**5<sup>th</sup> Further Information**

**Proposed Temporary Warehouse (excluding Dangerous Goods Godown) with Ancillary Facilities  
for a Period of 3 Years and Associated Filling of Land and Pond in "Agriculture" Zone,  
Lot 1291 (Part) in D.D. 107, Fung Kat Heung, Kam Tin, Yuen Long, New Territories**

**(S.16 Planning Application No. A/YL-KTN/1004)**

**Responses-to-Comments**

| REV  | DESCRIPTION | DATE |
|--|-------------|------|
| DRAWING NUMBER<br><b>FIGURE 3D</b>               |             |      |

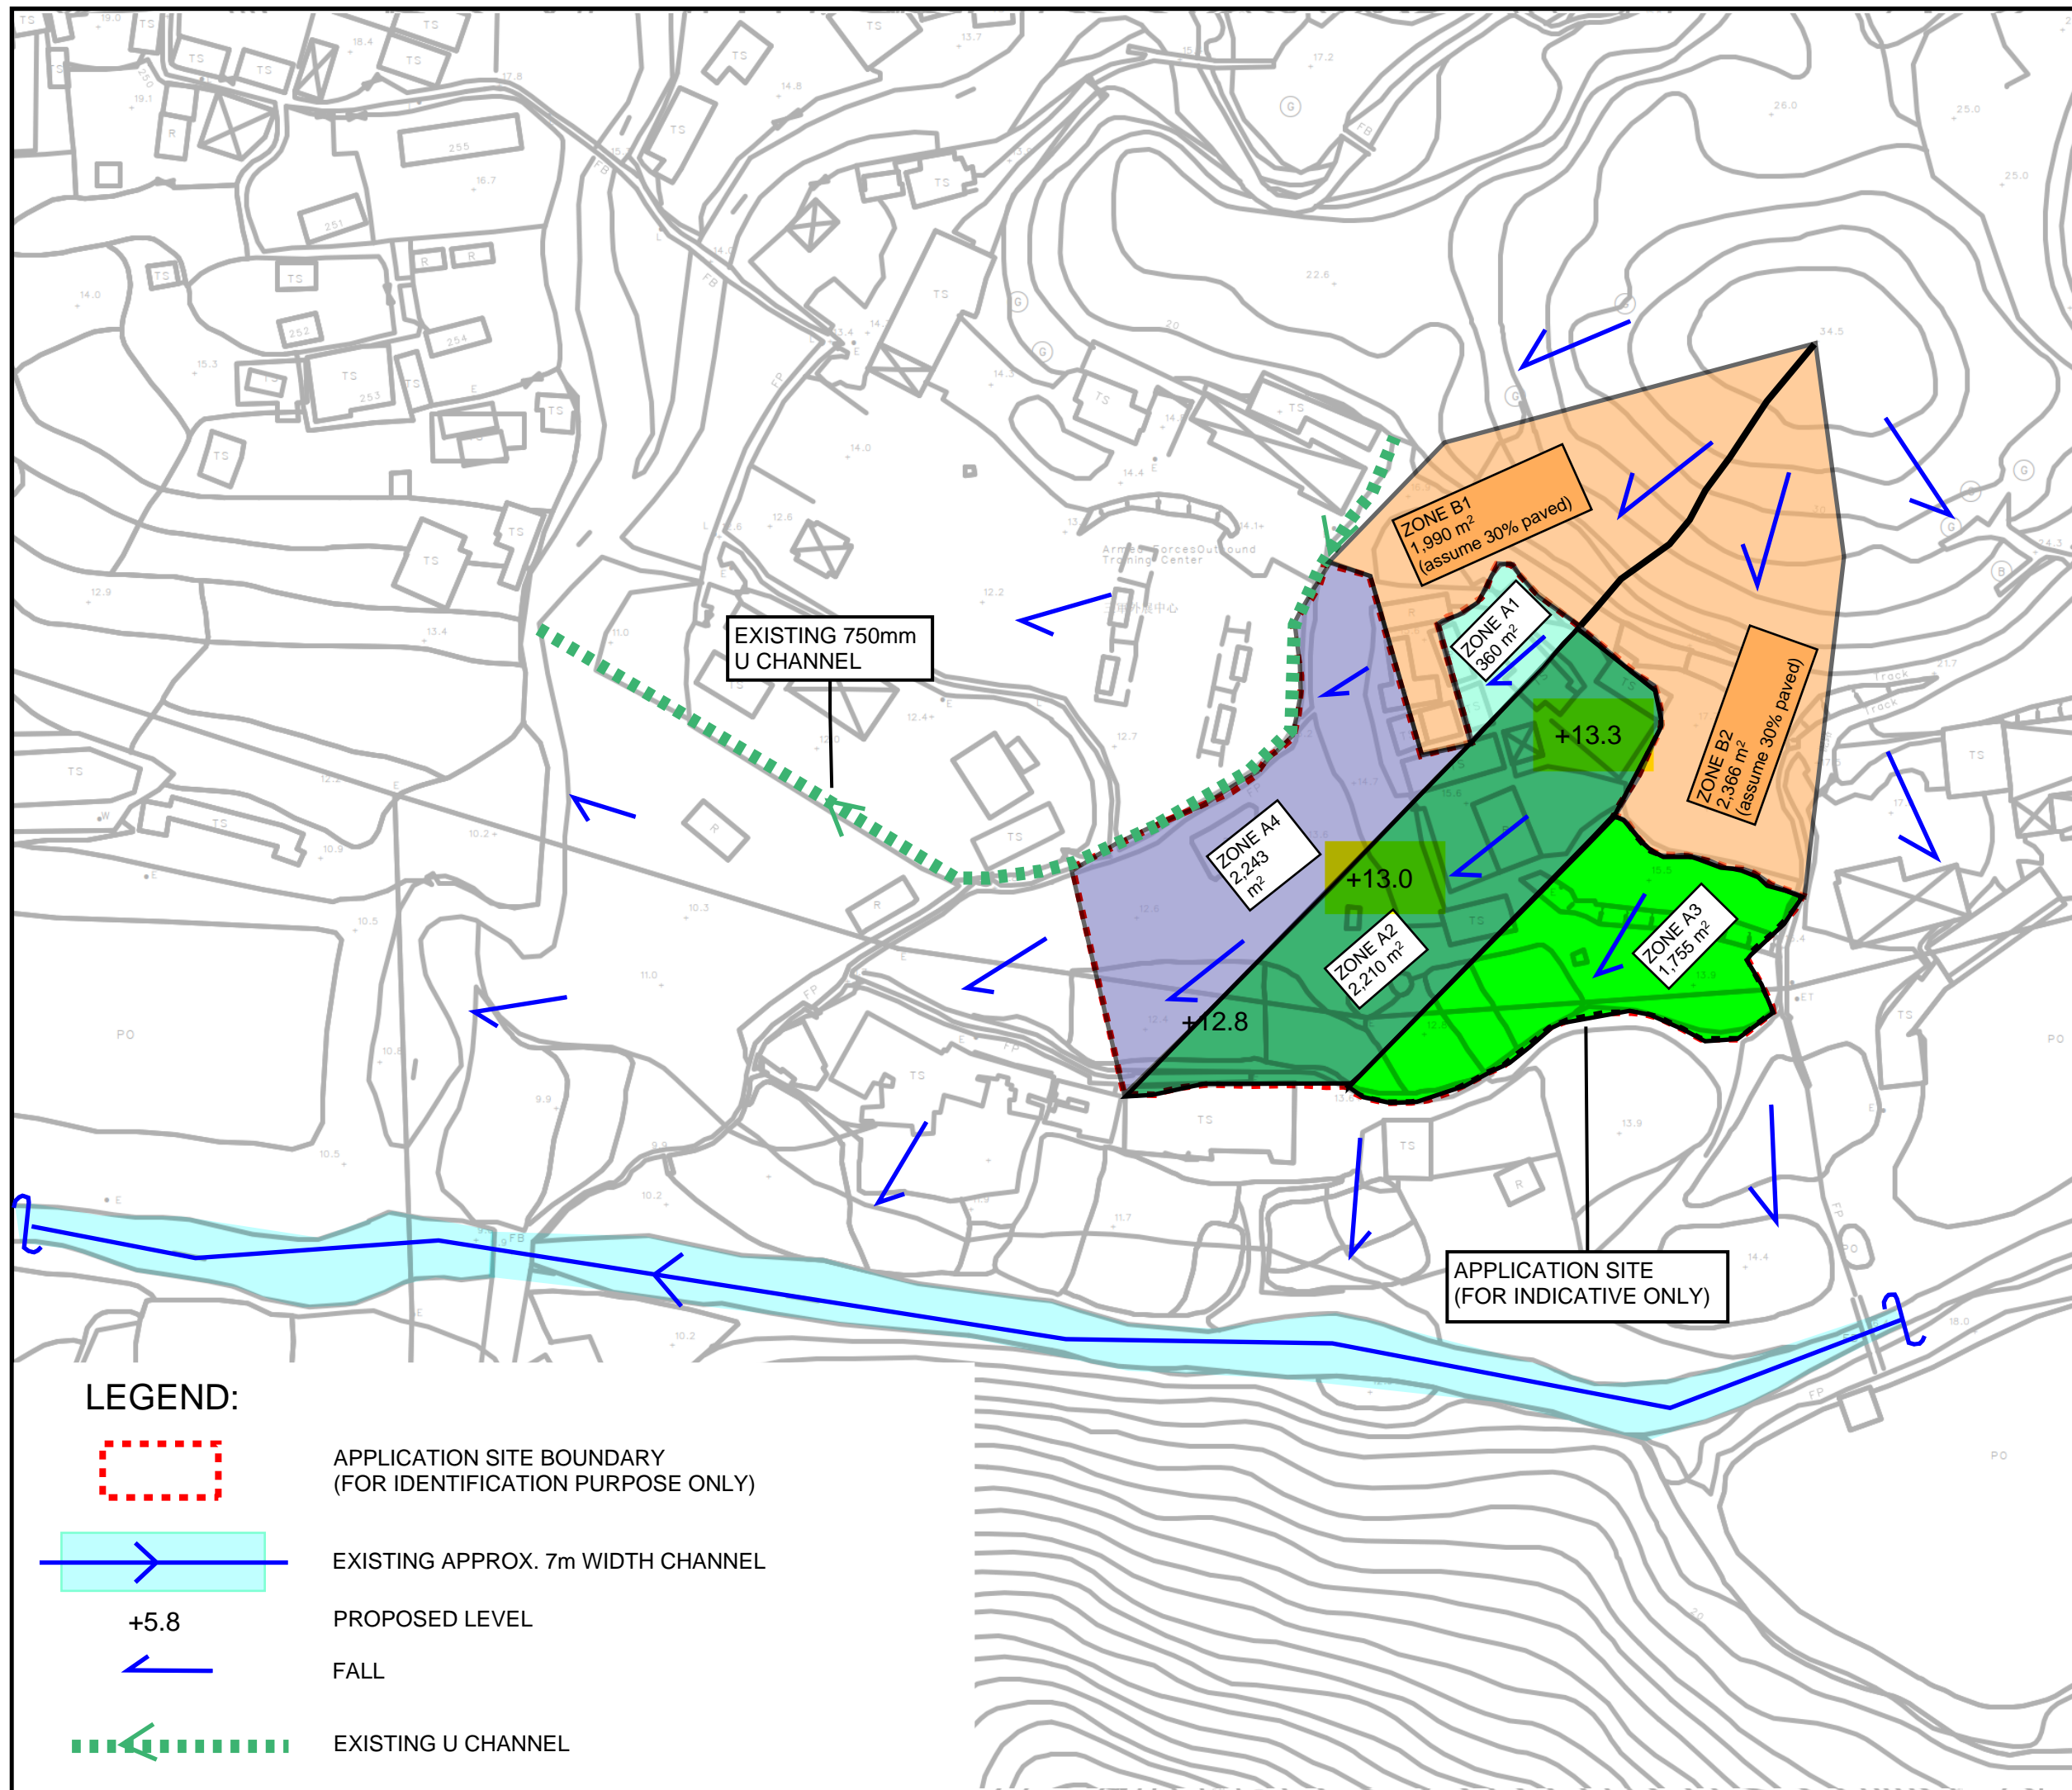
| Departmental Comments  |  | Applicant’s Responses   |
|--|--|---|
| (a)  | The 300UC in Appendix D Section does not tally with the size given in drainage proposal. | <p>Please note the 300UC in Section 1 of “Appendix D – Section” is UC3 which 300mm U-channel as proposed in Figure 3 (<b>Annex II</b>).</p> <p>Please also note that the existing ground level information is updated as per the most updated available information. Please refer to the page 2 of Appendix B.</p> <p>The proposed levels are updated accordingly in Figure 3, Figure 4 and Appendix D (highlighted in yellow).</p> |
